FORD AOD 3-4 ACCUMULATOR ELIMINATED

Figure 1

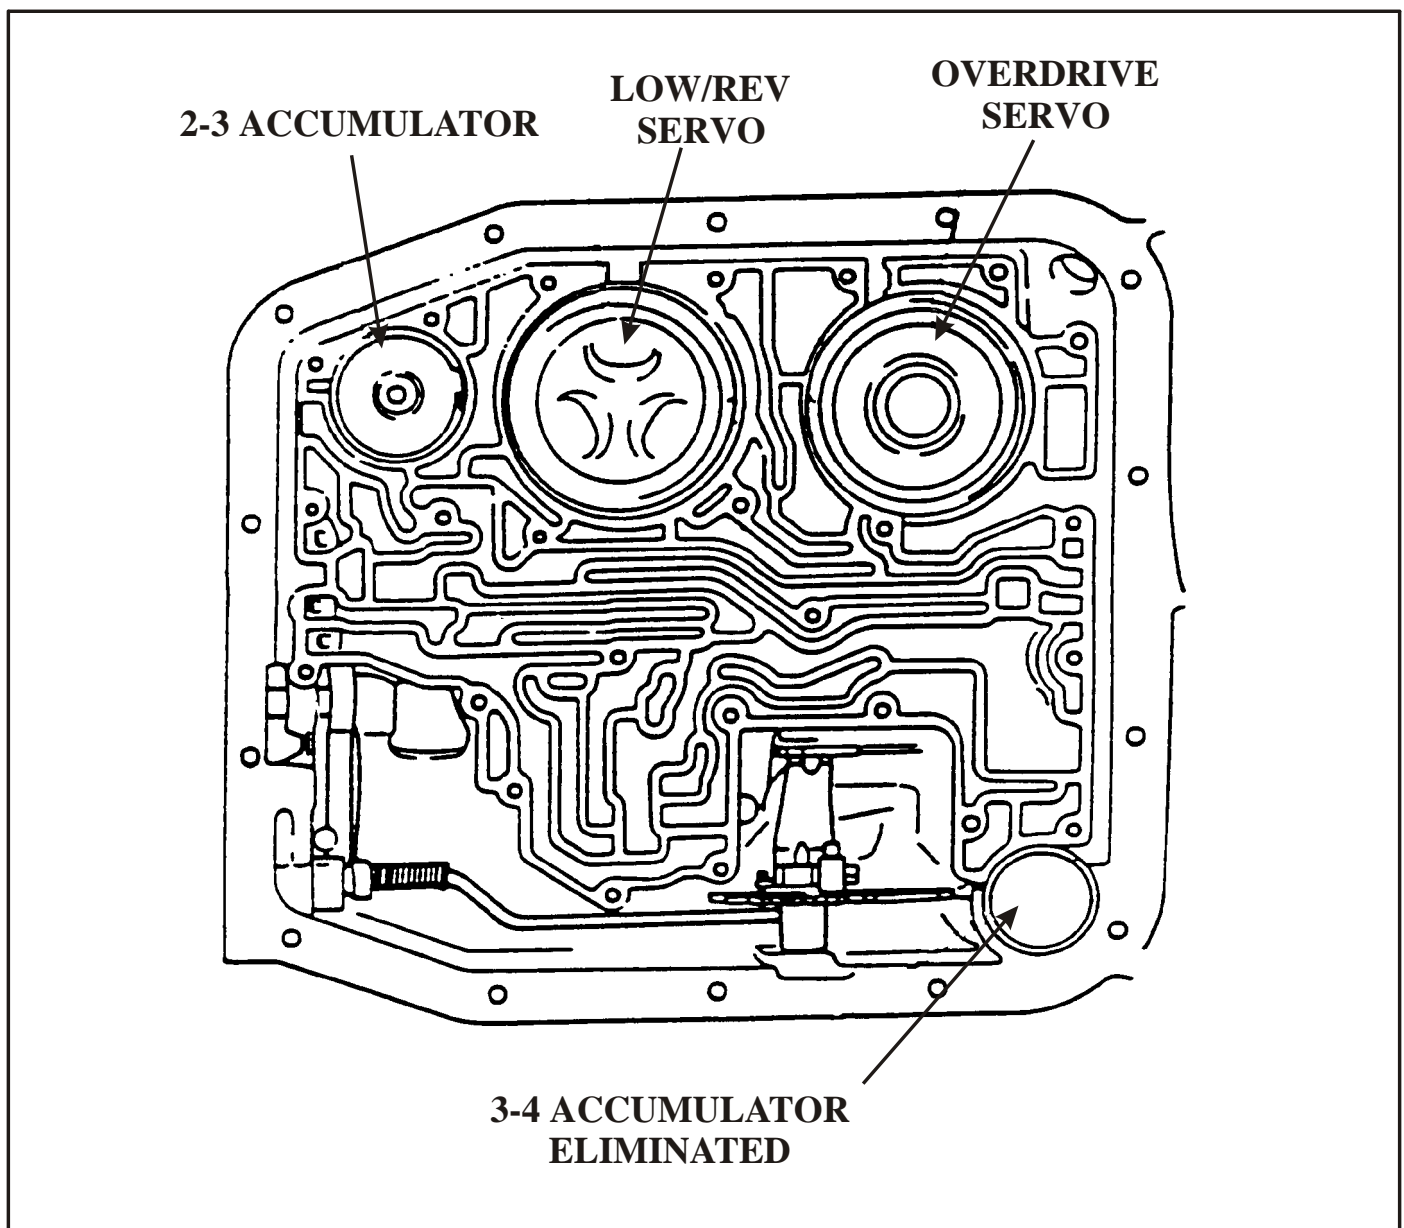
The 3-4 shift accumulator used in prior model year "AOD" transmissions is no longer used in 1989 "AOD" transmissions except on vehicles that are equipped with 5.8L engines. The accumulator feed hole in the main control assembly has been blocked so a 3-4 shift accumulator can not be installed. Only use a 1989 control assembly to service a 1989 "AOD" transmission. The 1989 main control assemblies can be used to service all prior model year "AOD" transmissions even if the old main control assembly has a 3-4 shift accumulator.
